T1250A-02

Modification Recommended Service Note

T1250A - Smart RF Switching Unit

The following picture shows the Power Distribution Board (T1250-60009), and its location in the T1250A:

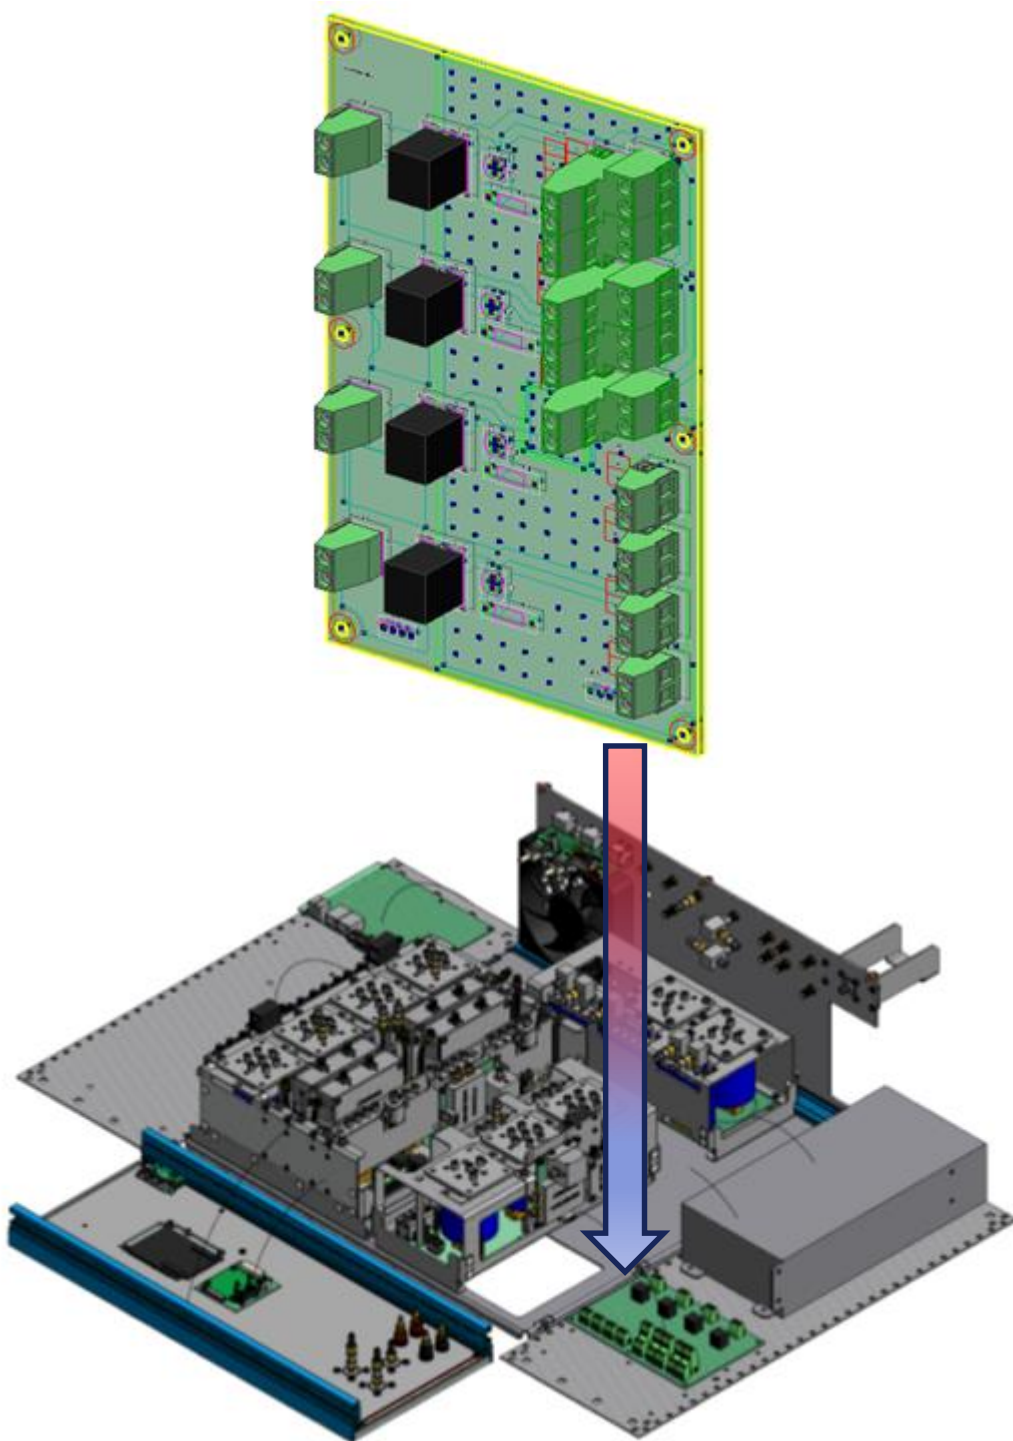
Some spurious were found at frequency 98.4 KHz and its harmonics (196.8 KHz, 295.2 KHz...), which come from the T1250A Power Supply Unit. In some cases, the main 98.4 KHz spurious could be measured above the threshold level of the 3GPP test case 6.6.3.1 (“Transmitter spurious emissions”), thus producing a ‘ false’ spurious (it does not come from the UE under test).

AWG18 and 35 cm long ground cable

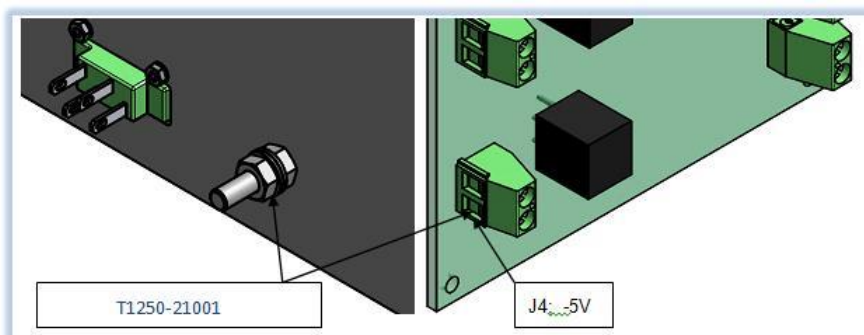
- i. Open upper cover of T1250A
- ii. Remove the GND cable “T1250-21001” (obsolete version) that goes from J4 connector of the Power Distribution Board “T1250-60009” to chassis:

Installation of ground cable T1250-21001

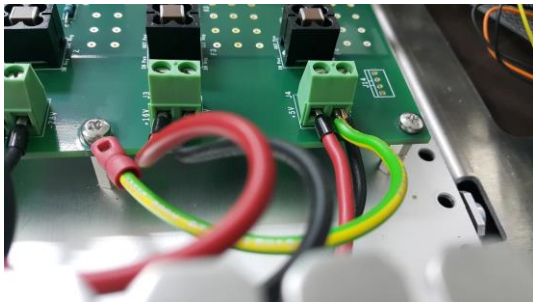
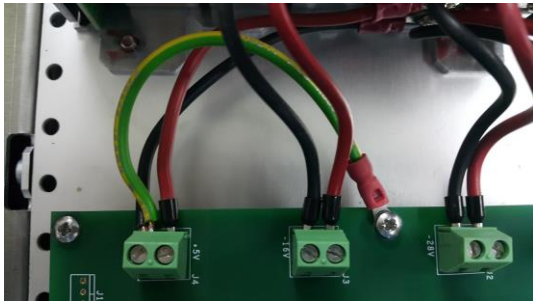
- iii. Connect the cable “T1250-21001” (new version) from J4 of the Board “T1250-60009” to the chassis screw of the same board as shown in the following Pictures:

AWG16 and 10 cm long ground cable

- 1- Power Distribution Board, pn: T1250-60009, included with engineering change ECO0326469 (May 2013), as part of the production transfer from Málaga to Penang. The first serial number incorporating this board is MY53301001.
- 2- Ground cable, pn: T1250-21001, was modified in June 2015, through ECO0372327:
 - a. Cable length was reduced from 35cm to 10cm
 - b. Type of cable changed from AWG18 to AWG16
 - c. One of its end connection points changed from chassis to a screw that attaches the board to the chassis through a standoff (see pictures below). The first serial number with this change is MY54050148
